# ADDENDUM No. 1

ITB No. 4426

## SPRINGWATER SUBDIVISION IMPROVEMENTS PROJECT PHASE II

The following changes, additions, and/or deletions shall be made to the Invitation to Bid for **ITB No. 4426 Springwater Subdivision Improvements Project – Phase II**, on which proposals will be received on/or before Thursday, April 14, 2016, by 2:00P.M.

**PROJECT MANAGEMENT - PUBLIC SERVICES - CITY OF ANN ARBOR**  
**SCALE: N/A**  
**SPRINGWATER SUBDIVISION - PHASE II**  
**NOTES AND TYPICAL ROAD CROSS SECTION**  
 DRAWING NO. 2015018-3  
 SHEET No. 3 OF 68

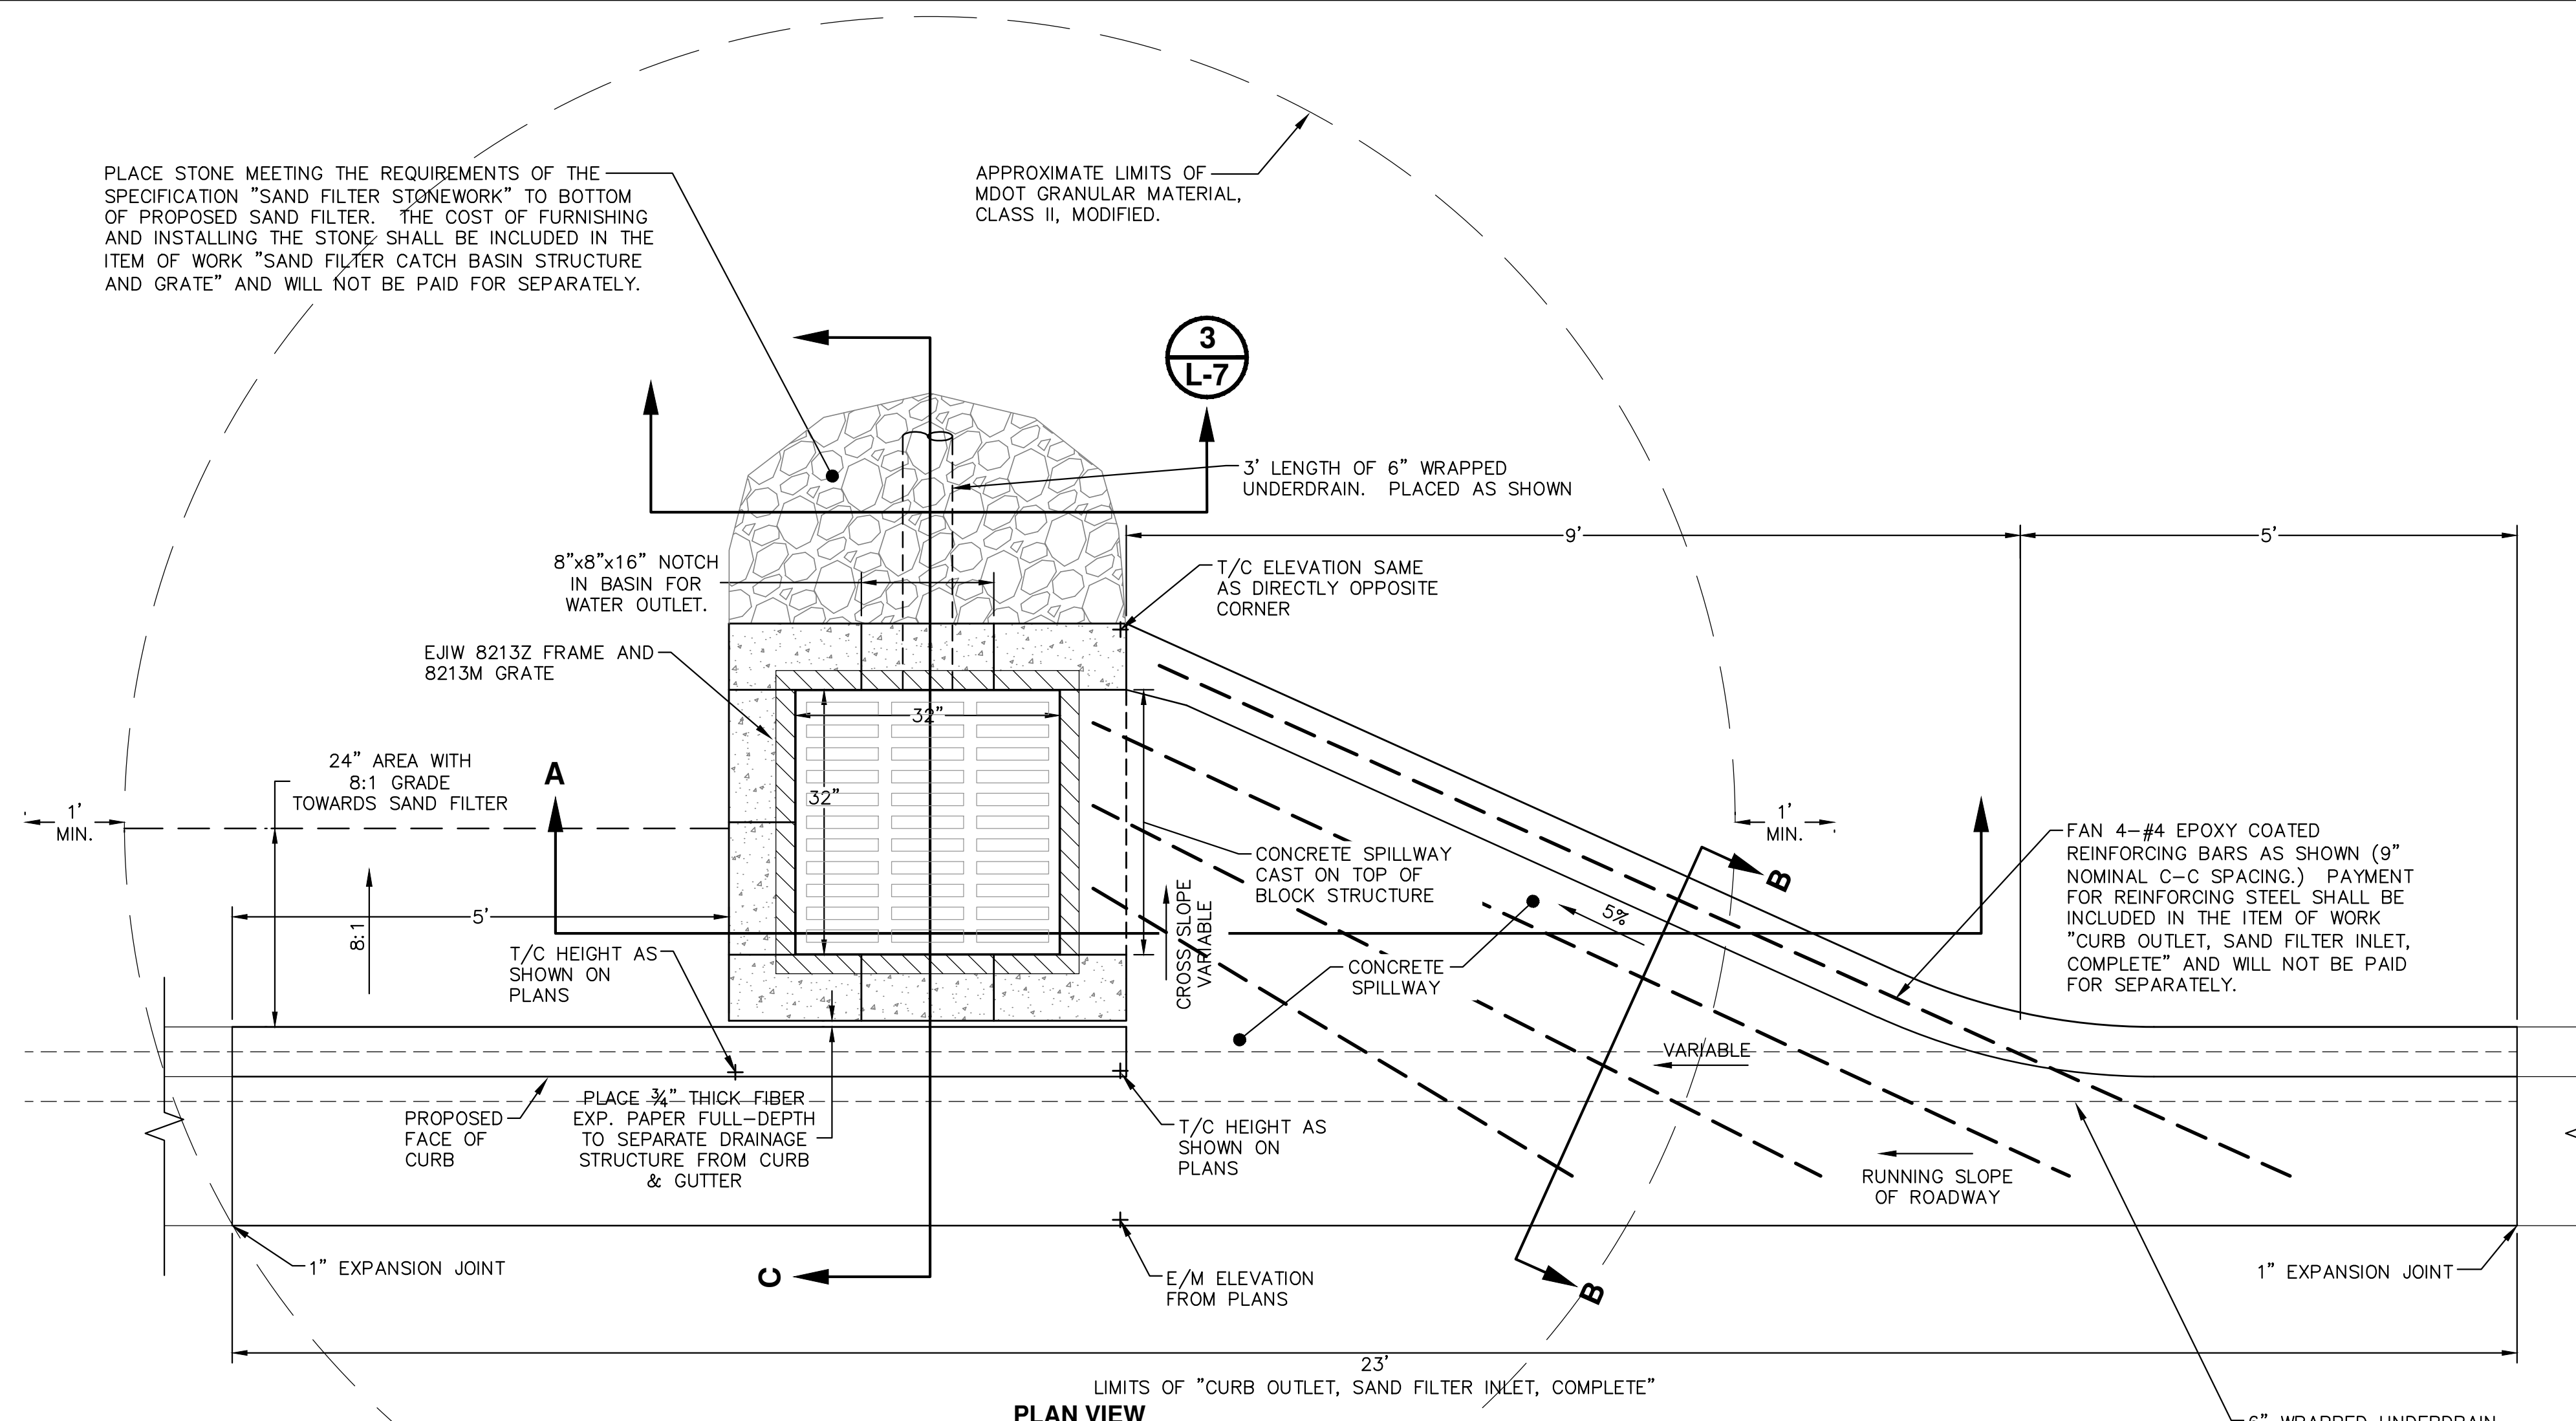
DS-36 – DS-42	The “Detailed Specification for Acceptance of HMA Mixtures” shall be deleted.
DS-79 – DS-85	These pages shall be removed and replaced by DS-79-R-1 through DS-85-R-1, which are attached below.
Plans Sheets 3, 6, 7 & 8	<p>These plan sheets shall be removed and replaced with the attached plans sheets #3, 6, 7 and 8. The significant changes to these plans sheets include the following:</p> <p>On plan sheet #3 the 12 inch sand subbase, CIP is shown to consist of MDOT Granular Material Class II, Modified.</p> <p>On plan sheet #6 the PVC membrane surrounding the sand filter was eliminated.</p> <p>On plan sheet #7 the aggregate stone barrier was eliminated at the top of the Sand Filter Overflow Structure detail.</p> <p>On plan sheets #4 &amp; #8 the aggregate backfill over the underground storage chambers is now identified as clean, washed MDOT 6A stone.</p>

- c. The 12 inch sand subbase, CIP in the road shall consist of MDOT Granular Material Class II, Modified. This change will be reflected in Addendum #1.
